ADDENDUM

PROJECT: Waverly Lawson Park
Phase II Improvements
Waverly, Nebraska

AD-1

DATE ISSUED: Wednesday, September 10, 2014

From Sheet A-503C	for CA use:
Drawing # A-503C.1

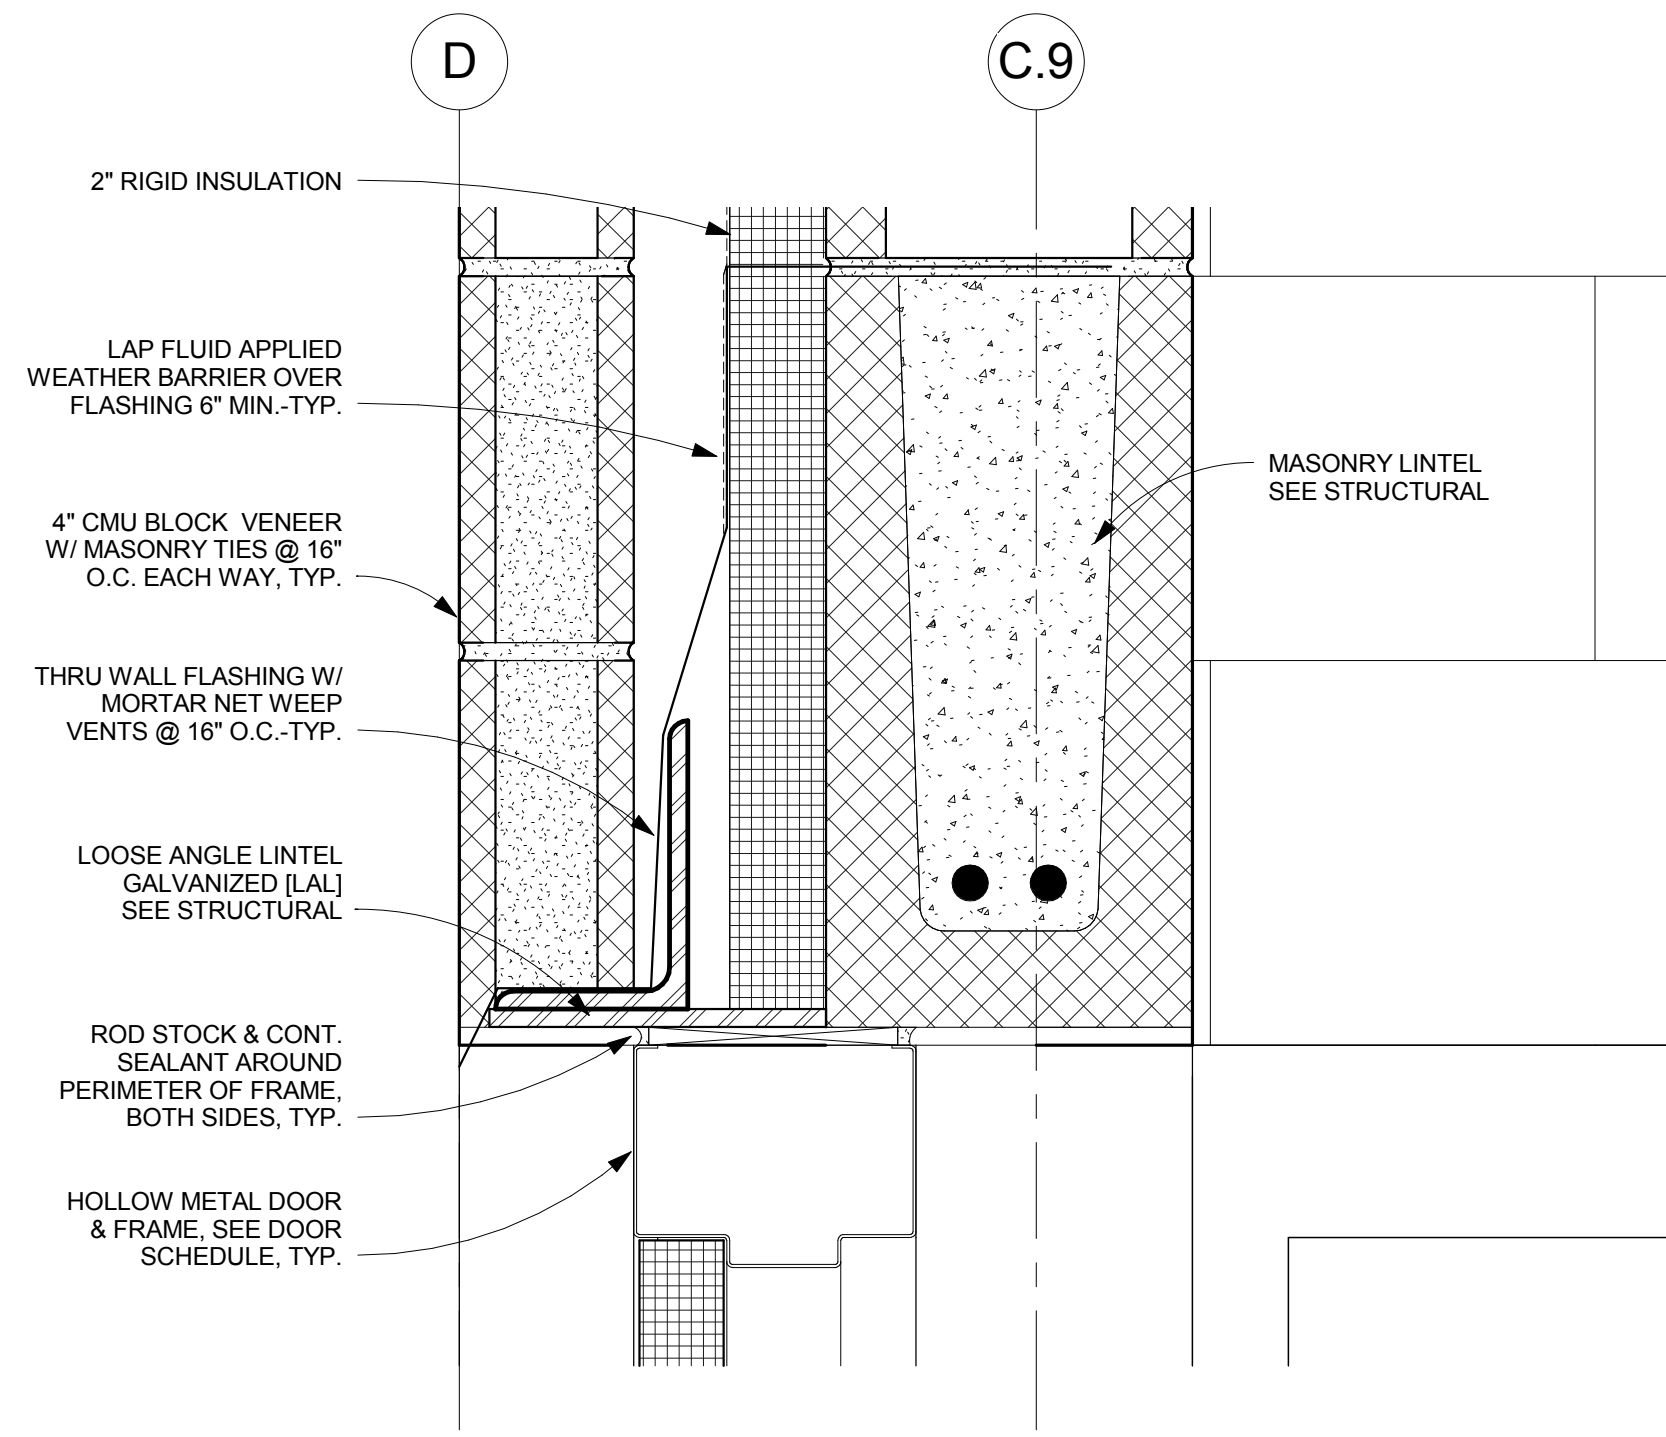
In reference to Sheet A-503C - Details, door head detail 5 has been added. See attached Supplemental Drawing A-503C.1.

From Sheet A-503C	for CA use:
Drawing # A-503C.2

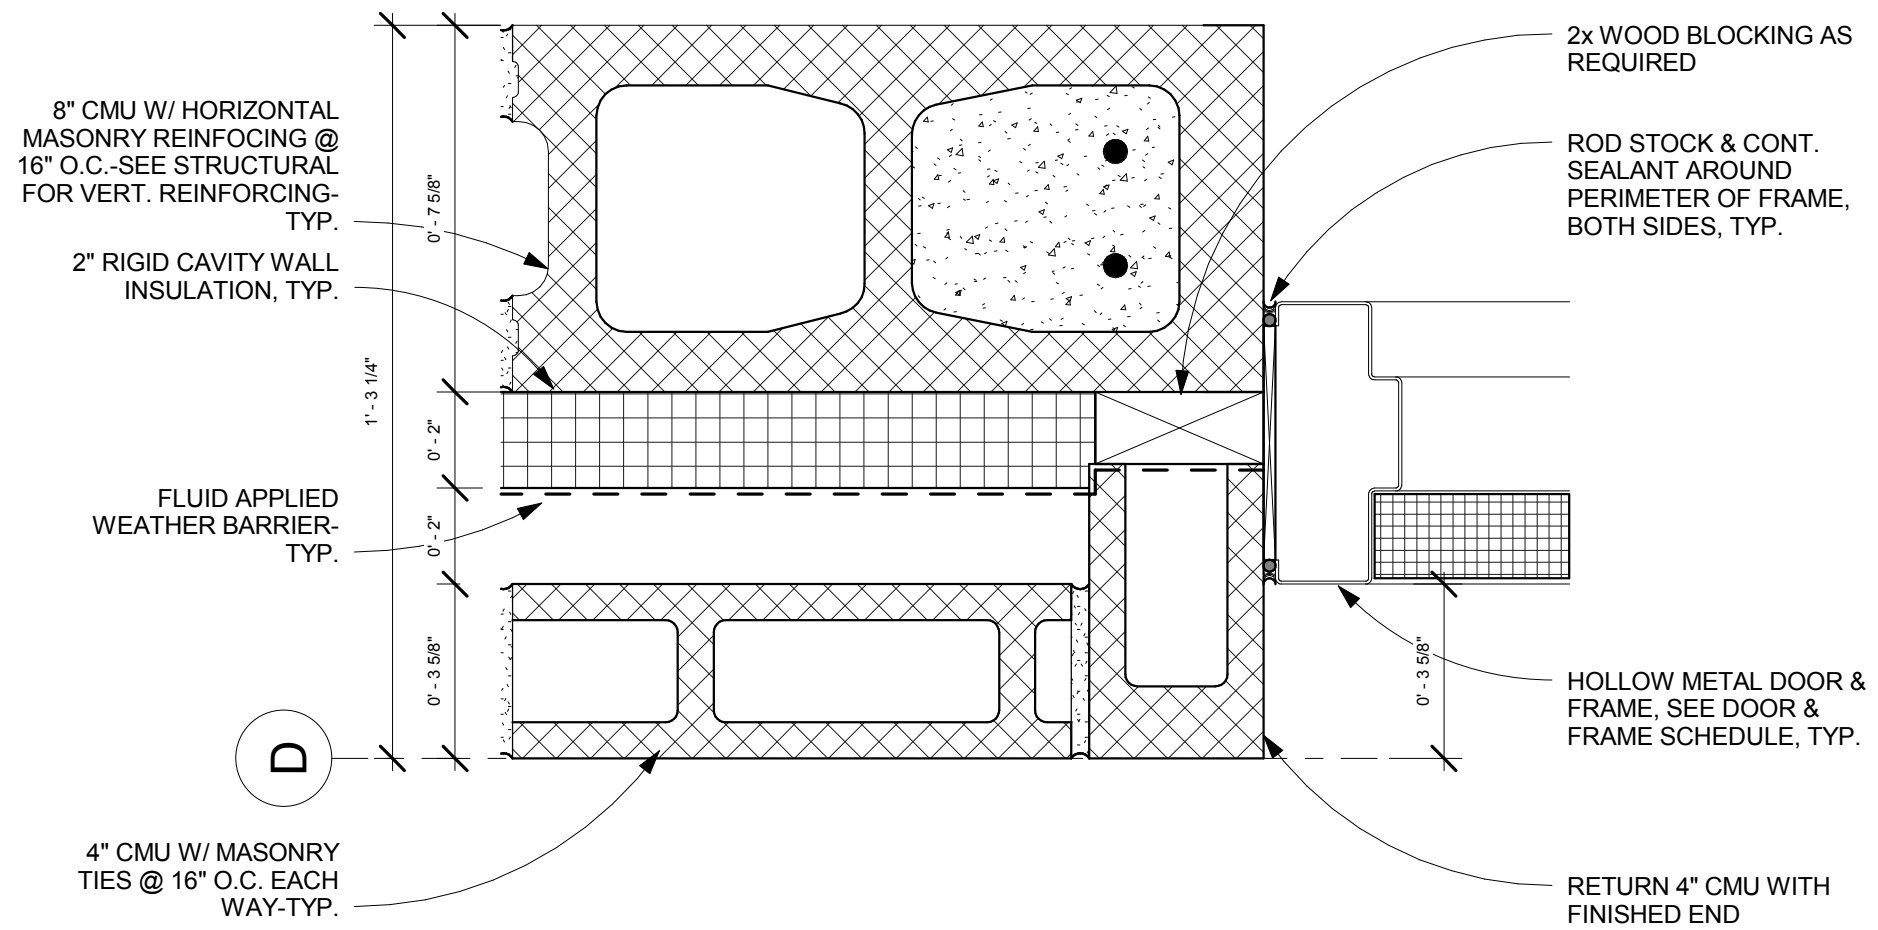
In reference to **Sheet A-503C - Details**, door jamb detail 7 has been added. See attached Supplemental Drawing A-503C.2.

From Sheet A-503C	for CA use:
Drawing # A-503C.3

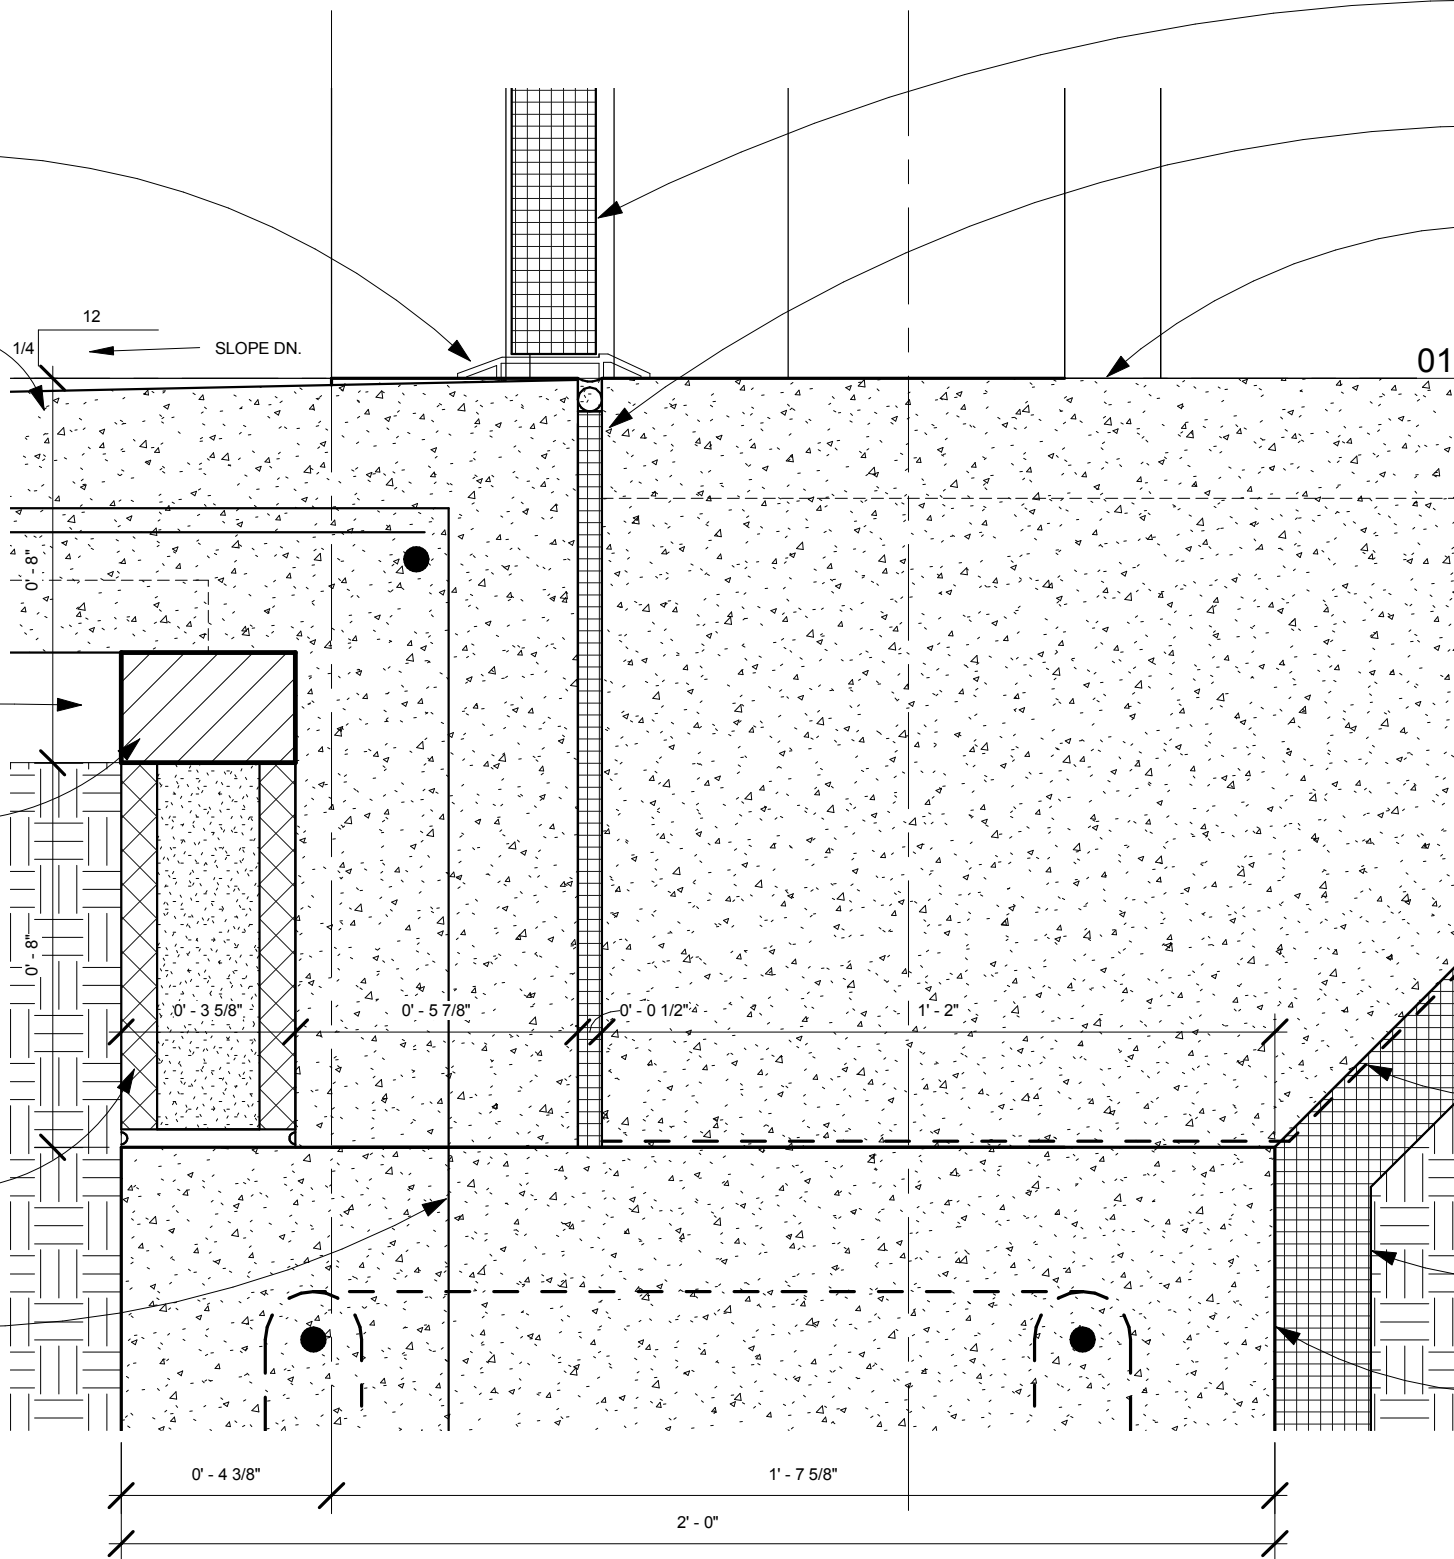
In reference to **Sheet A-402C - Wall Sections**, the frost slab shown on wall section 1 shall reference detail 6 shown on sheet A-503C. See attached Supplemental Drawing A-503C.3.

In reference to **Sheet A-503C - Details**, frost slab detail 6 has been revised, this detail corresponds to the frost slab shown on wall section 8, sheet A-401C and wall section 1, sheet A-402C. See attached Supplemental Drawing A-503C.3.

From Sheet A-504C	for CA use:
Drawing # A-504C.1

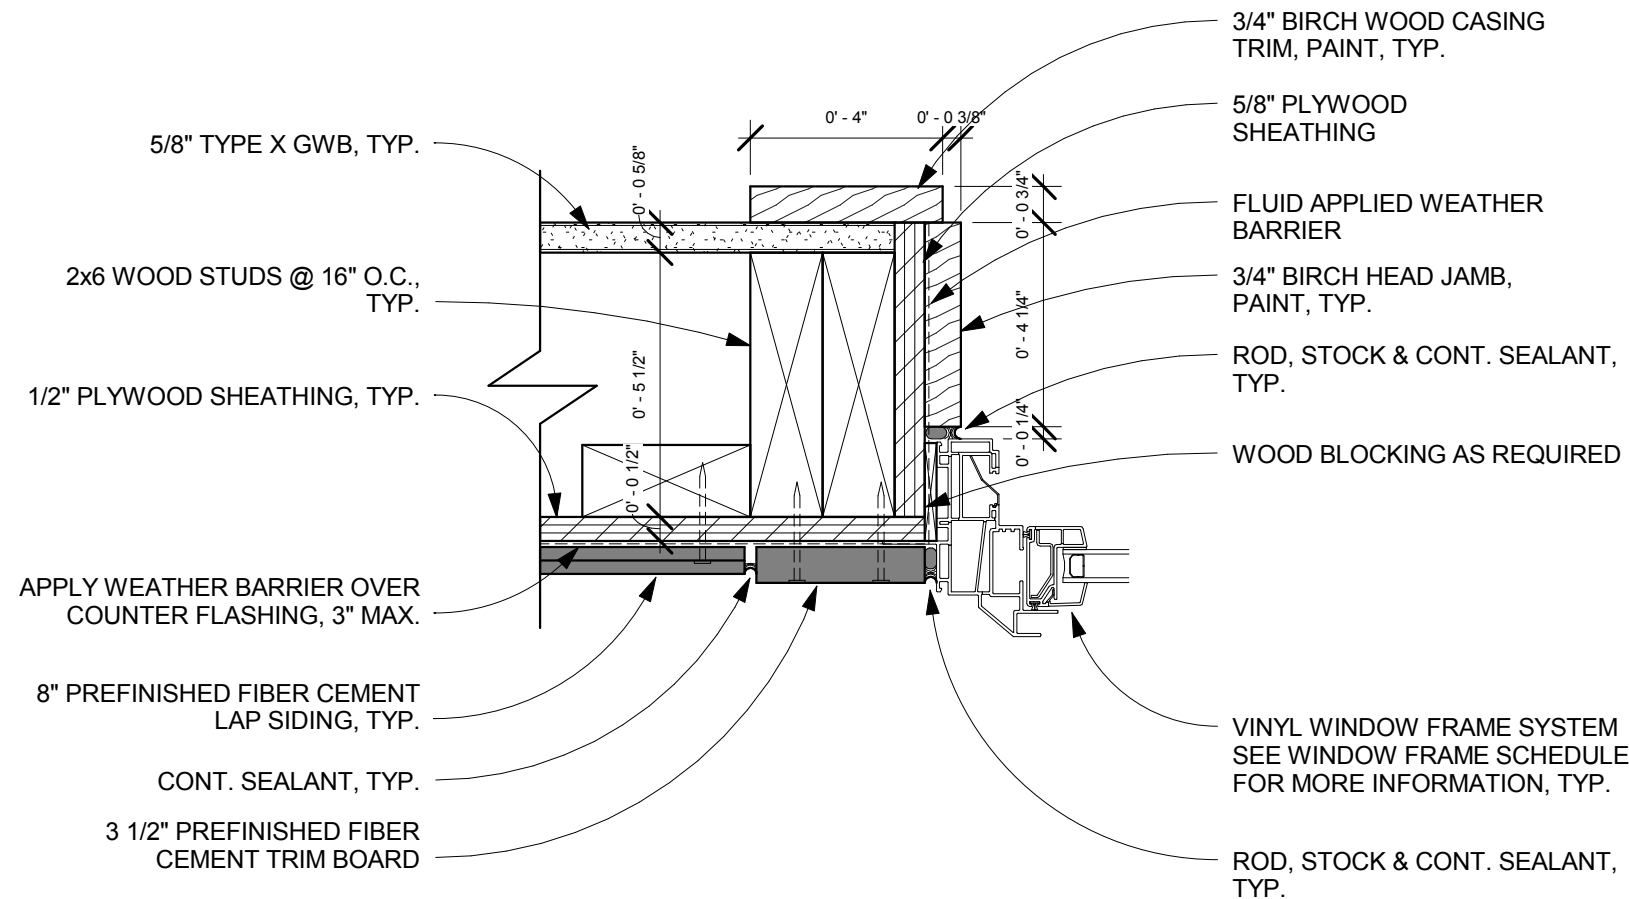
In reference to **Sheet A-504C - Details**, jamb detail 5 has been added to the sheet. See attached Supplemental Drawing A-504C.1.

From Sheet A-505M	for CA use:
Drawing # A-505M.1

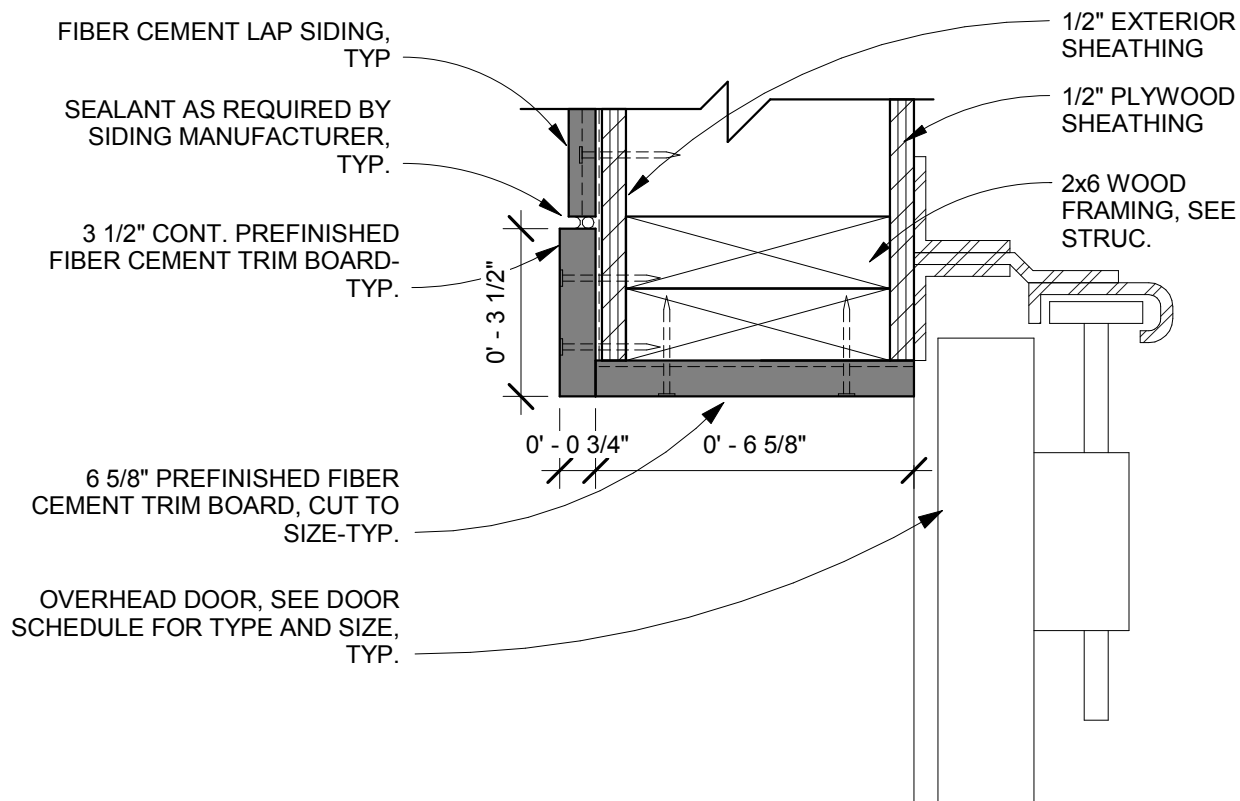
In reference to **Sheet A-505M - Details**, a jamb detail for the overhead door has been added to the sheet. See attached Supplemental Drawing A-505M.1.

From Sheet A-506	for CA use:
Drawing # A-506M.1

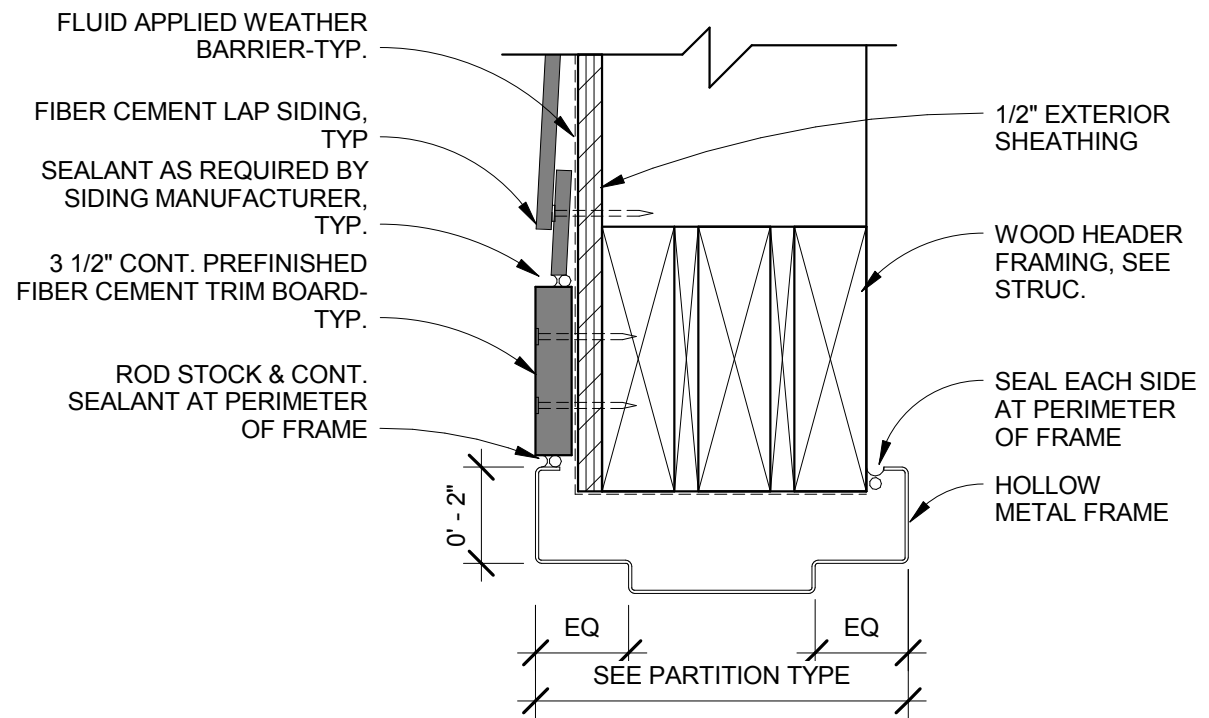
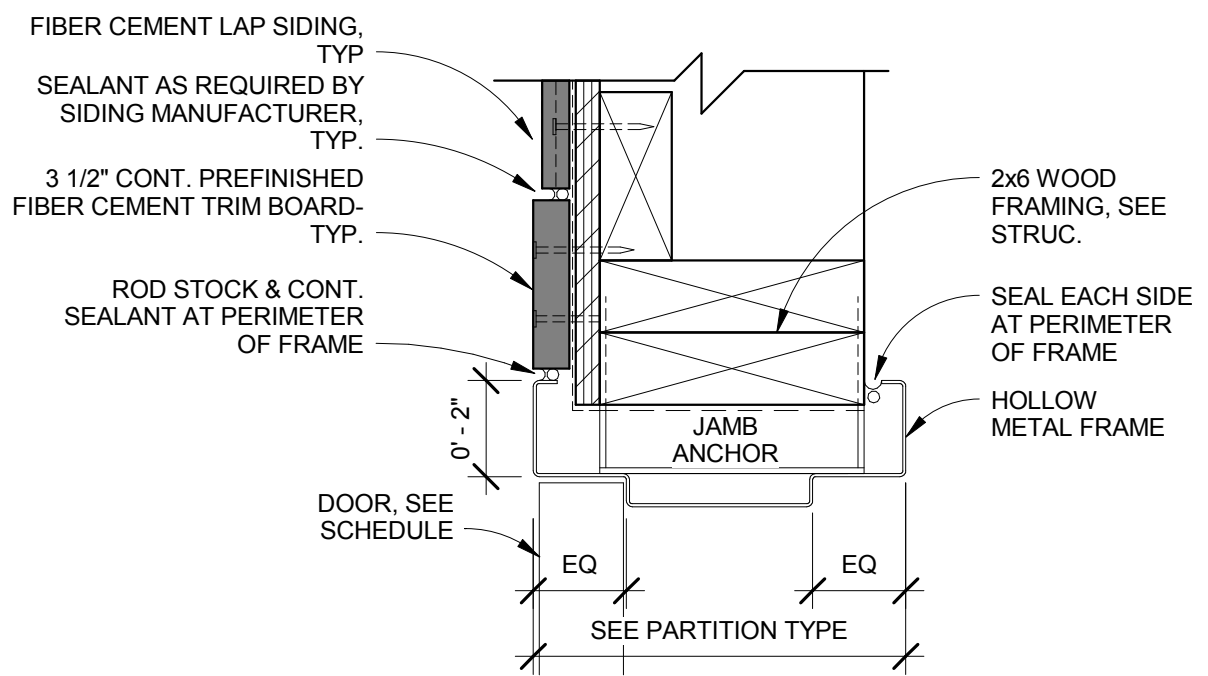
In reference to **Sheet A-506M - Details**, door jamb & head details 1 & 3 have been added to the sheet. See attached Supplemental Drawing A-506M.1.
